MONITORING REPORT (MY4)

ALLIANCE HEADWATERS MITIGATION SITE

Response to Monitoring Year 4 (2023) DMS Comments

Alliance Headwaters Stream and Wetland Mitigation Site (DMS #97086)
Neuse River Basin 03020201, Johnston County
Contract No. 6832

Legend

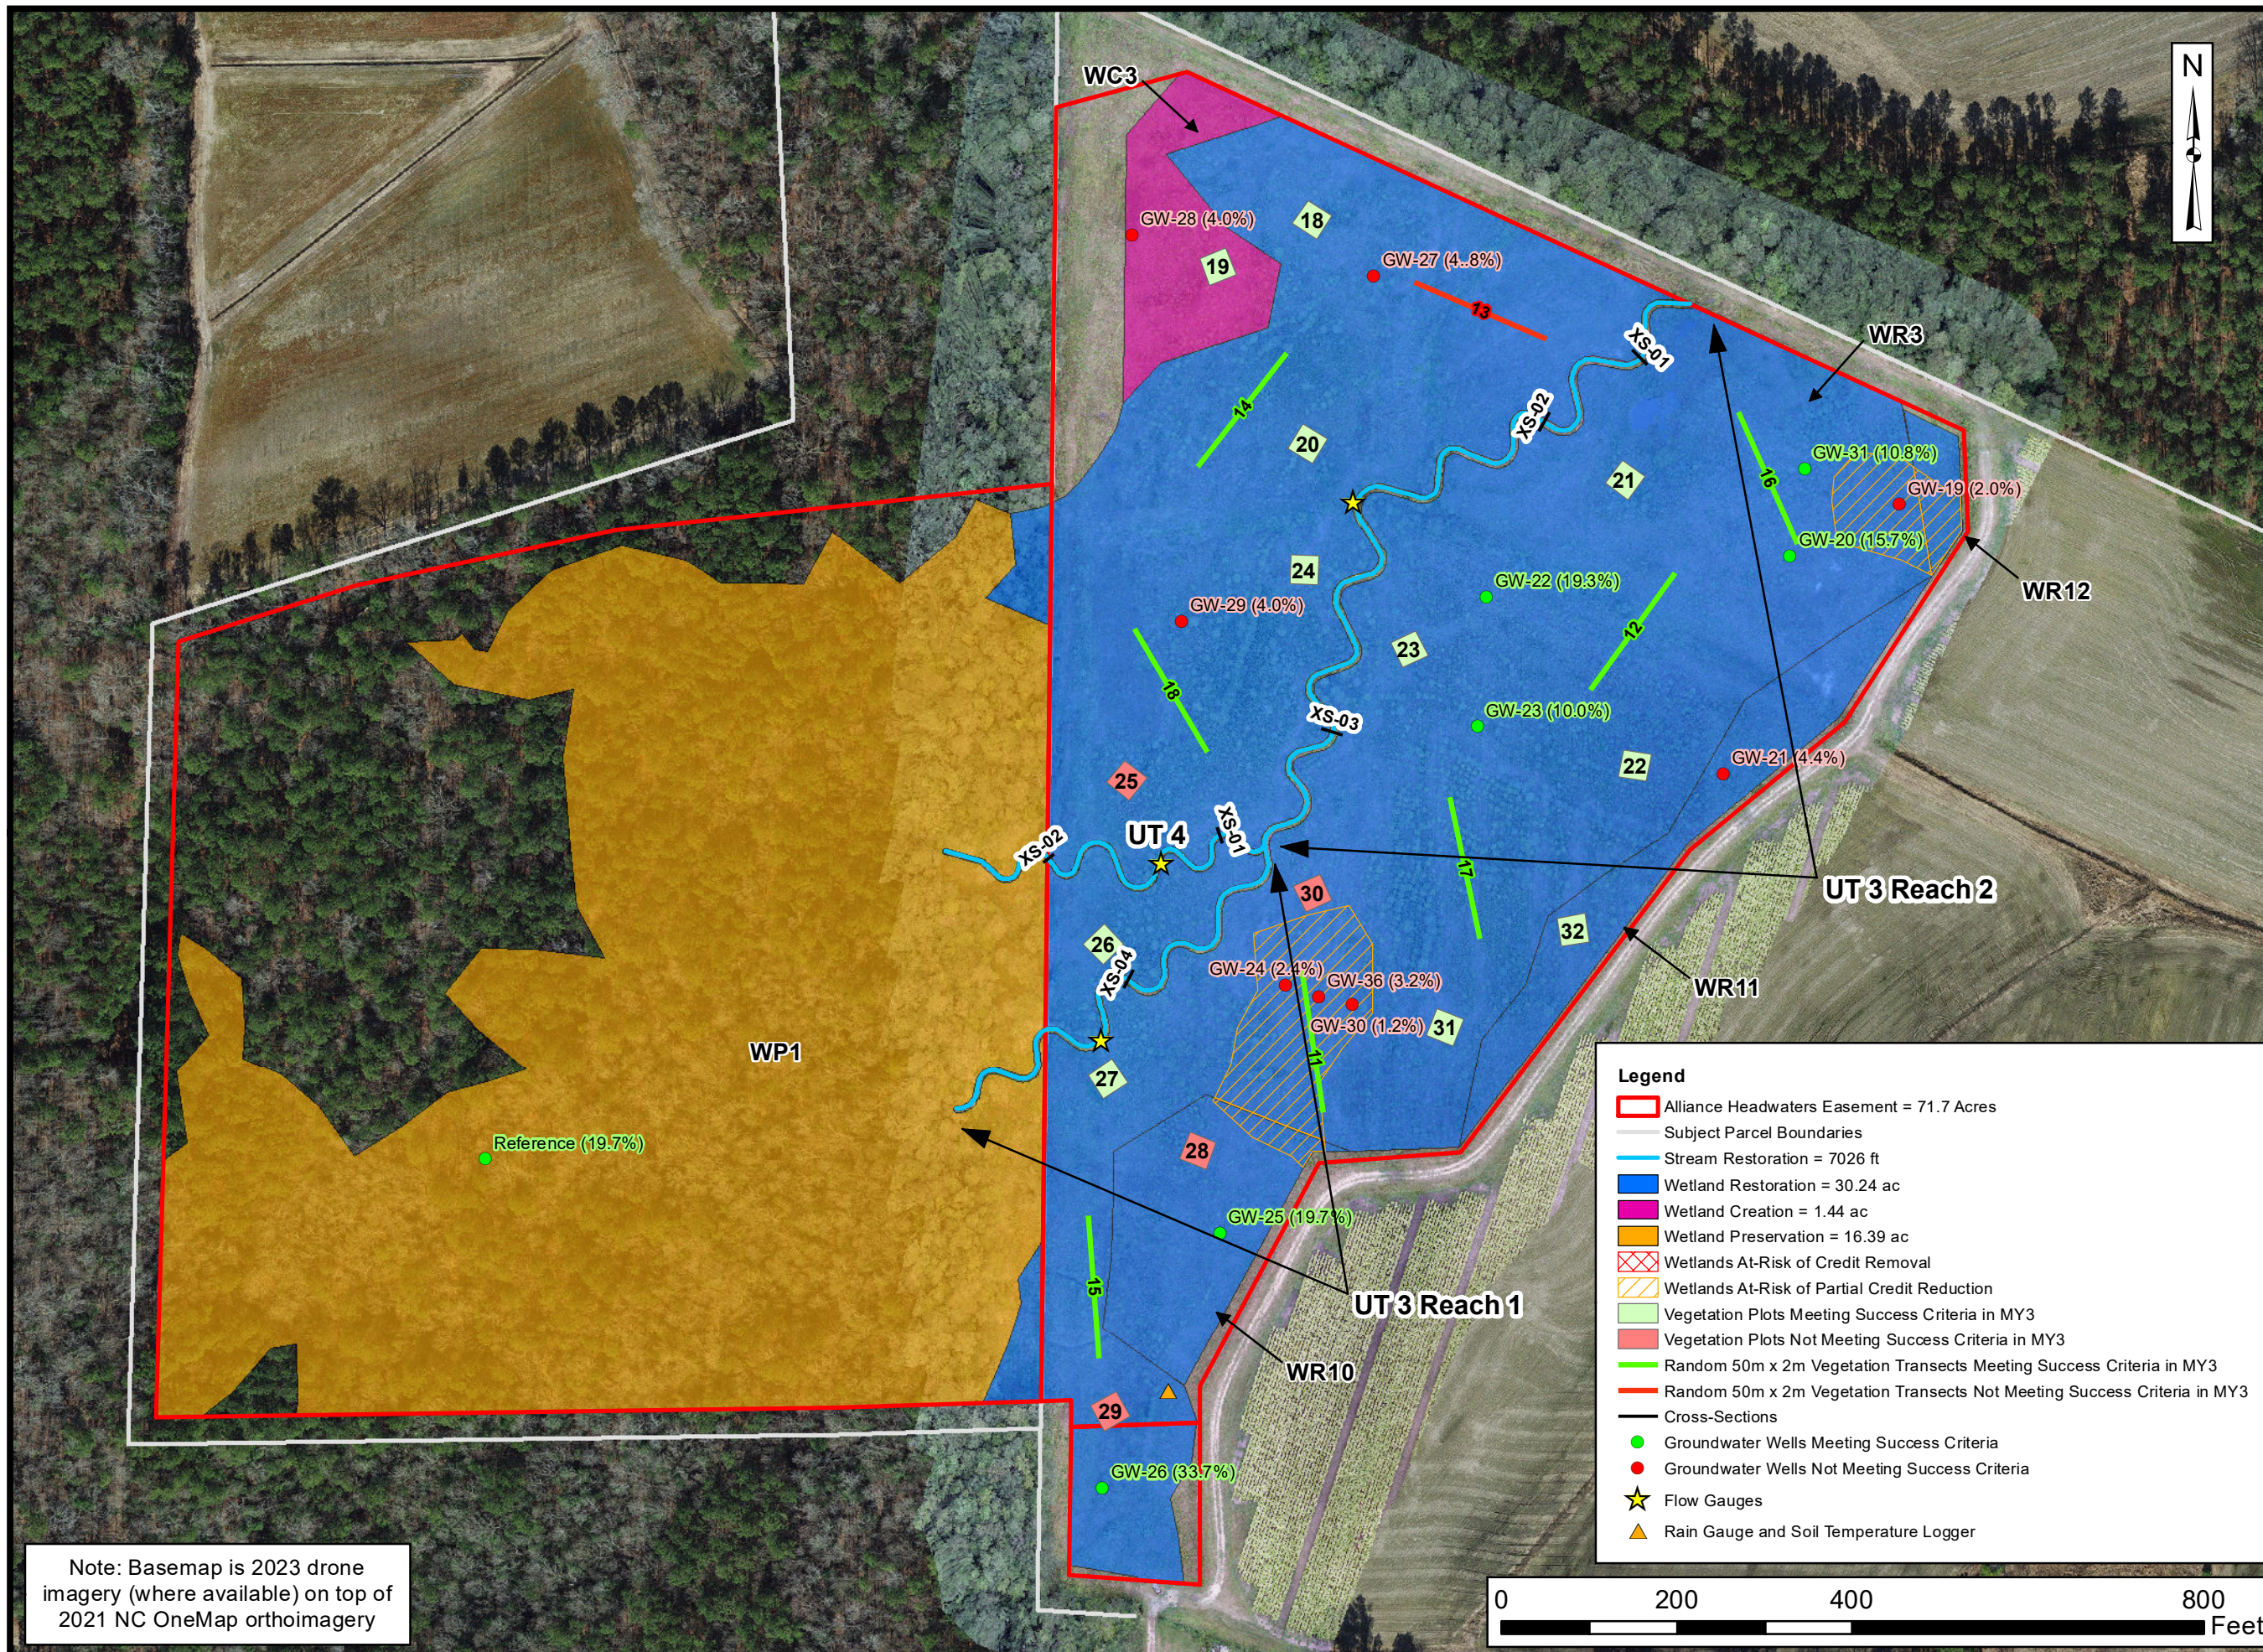
2. CCPV – Please map the at-risk wetlands.
Response: The wetlands at risk referenced in the response to comment 1 have been symbolized on the CCPV.
3. Table 11. Verification of Bankfull Events –
